4880 Pine Tree Drive Illustrated Responses for DRB Continuance

MTTR MGMT 291 NE 61st St Miami FL 33137

Improving Street Presence Part 2: Adding Meaningful Trees to the Front Yard

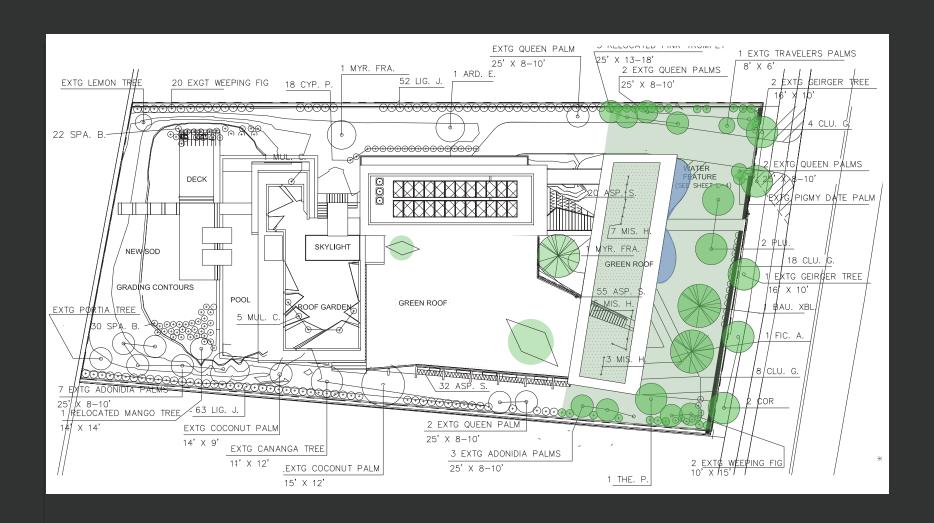
In this developed version we included specimen-size trees to the front setback to increase presence of meaningful plant life for the streetscape. The trees are two 18' native White Geiger trees. a 20' specimen Hong Kong Orchid, two 10' Frangipani Trees and a 20' native specimen Strangler Fig – in addition to two 25' Queen Palms and a Pigmy Date Palm. The total amount of trees/plants in the street setback is 42.

Improving Street Presence Part 3: Mid-Century Inspired Louver Redesign

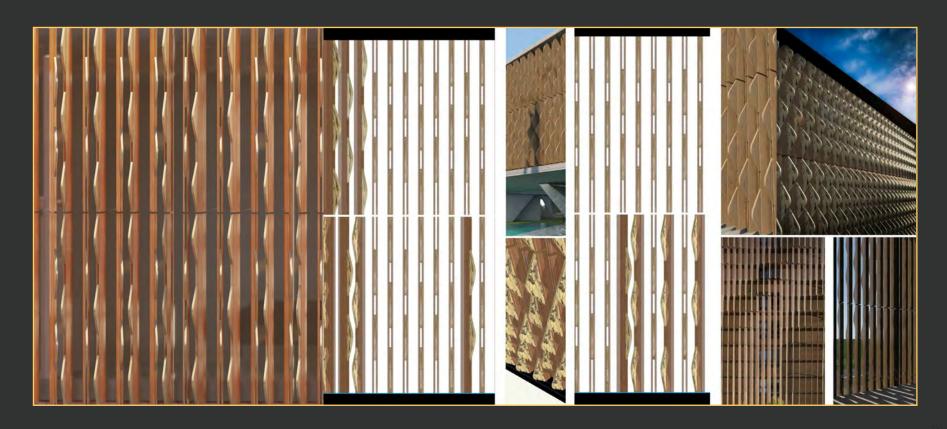
We provided a significant development for the street-facing louver system to improve the building's character. It is now made of a warmer color/material and its pattern is dynamic and mid-century inspired. It is also kinetic in the louver/fins angle to provide a variation in openness, which also translates into a variation of pattern – from straight down (wide open) to curvilinear wave pattern (when closed).

Understory Redesign

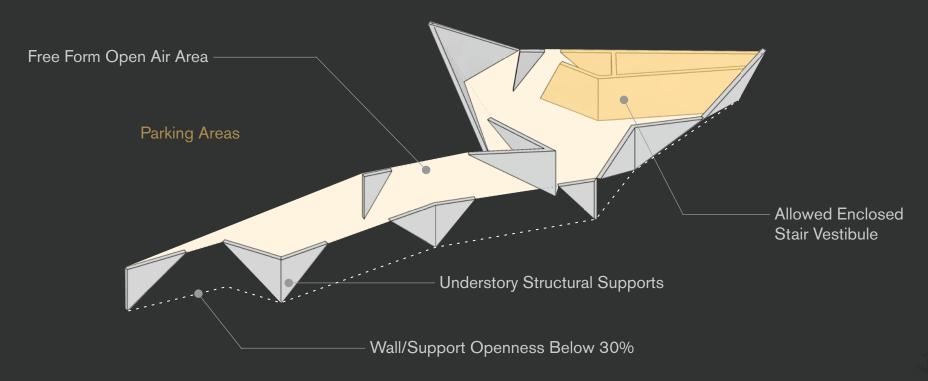
We have redesigned the understory to address the 'open it up by 30% and make it lighter'. As a result we have a much lighter, natural light-filled understory that is more open, including enhanced understory landscaping and a more varied palette of natural materials. The supports are farther between and we added a perforation to the roof in addition to the previous one – now with larger open areas. This supports the intent of the code for the understory, and we believe it is now a good example of a flood-resistant space. The spaces we enclosed are true vertical circulation elements as prescribed, the remaining areas being strictly about support.

Mitigating Effects on North and South Properties: Maximizing the Setback to the North and Buffering to the South

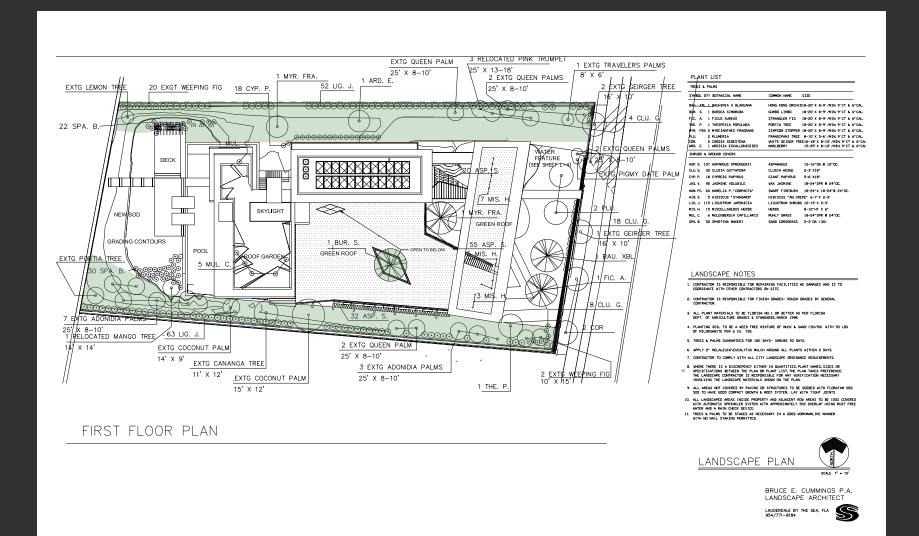
In response to the Staff's suggestion that we switch the maximization between N and S setbacks (the South facing side of the project having the lowest building mass) we responded by doing just that. We pushed the building to the South, making the setback with the North property effectively 15'-9" (previously 10'-6"). This, in combination with lowering 2' the height of the north-south building bar (2' from max available height through waiver – discussed below) and increased planting quantity and height (discussed in landscape section below), should minimize the shade and volume impact to the North. While this move has entailed relocating the driveway to the North, the intent was to mirror the North neighbor's driveway for a limited length to the advantage of the street scape so there is more uninterrupted green frontage which is consolidated with the South Property Line. The South property line has been enhanced by added planting buffers, which blend well with the smaller facing portion of the natural wood facades ~ and no vehicular movement.

Privacy in North Elevation by Using Translucent Glass

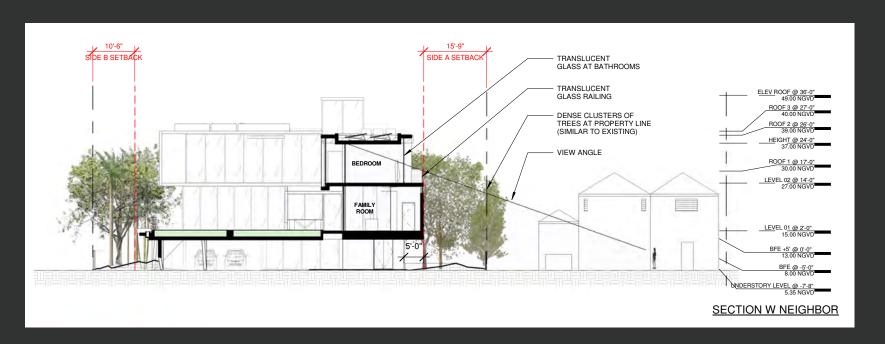
In addition to the before mentioned increased landscape screening – in quantity and in size, we have also used translucent glass to provide visual privacy in select areas: bathrooms and balconies. Translucent glass is highly diffusive and prevents visual recognition while allowing light to go through. It also decreases reflectivity. The increase of setback distance, reduced massing height, landscaping and material treatment are intended to provide screening and privacy at the viewing angles shown from adjacent property, in addition to the screening provided by trees. The rooms are 20'-9" from property line.

Building Shadow on Neighbor During the Year

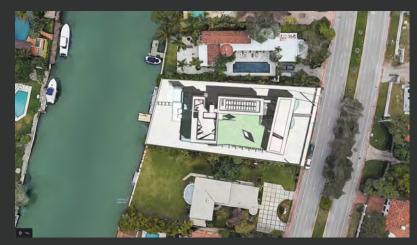
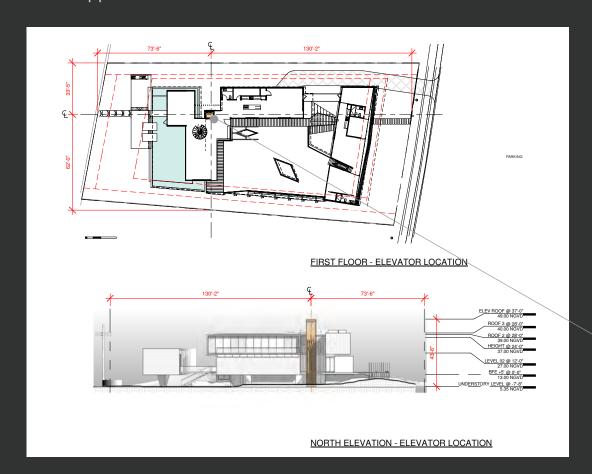
We are improving the performance of shadow coverage to the North (sun leans to the South in Northern Hemisphere) in this scheme by doing the following: reducing building height, placing building farther away by increasing setback and providing better layered landscape coverage and size. The shadow studies indicate that the building doesn't cast shadows on neighboring pool most of the year (75%), from February 3rd to November 6th, after that the shadows ranging from minor to partial. On the most prohibitive day of the year (December 21st) the shadow on neighboring property is partial and significantly reduced from previous scheme, as shown in Sun Studies.

Height Reduction in Building Massing to the North and to the West

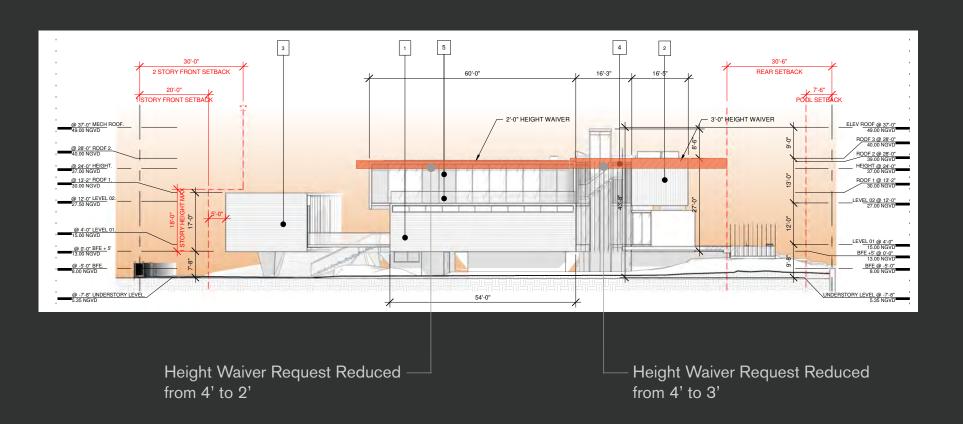
This scheme requires reduced height waivers than previously requested. On the North side of building we are requesting only a 2' increase (previously a 4' increase) and on the water side massing (West) we are requesting 3' (previously 4').

Improved Mitigation of Existing Trees and Addition of New Trees and Plants

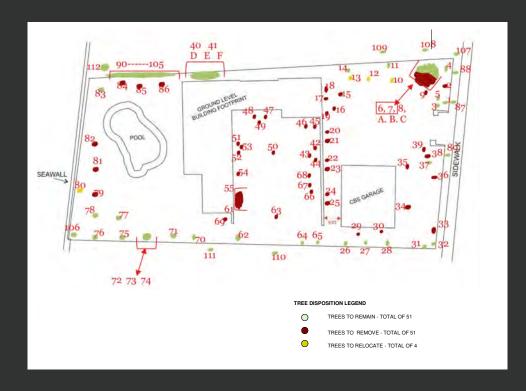
We are keeping more of the original trees and relocating more trees than in the previous scheme. In the previous submittal we were adding 5, now we are adding 11 trees. We were keeping 21 trees before, now we are keeping 51. Previously we were relocating 1 tree, now we are relocating 4. We reduced the amount of trees we are removing by 34. In addition to the beneficial location of to the new trees, we are planting an elevated extensive roof-yard over understory to reduce heat island effect and maximize green coverage, as well as an extensive planted roof for one of the living volumes.
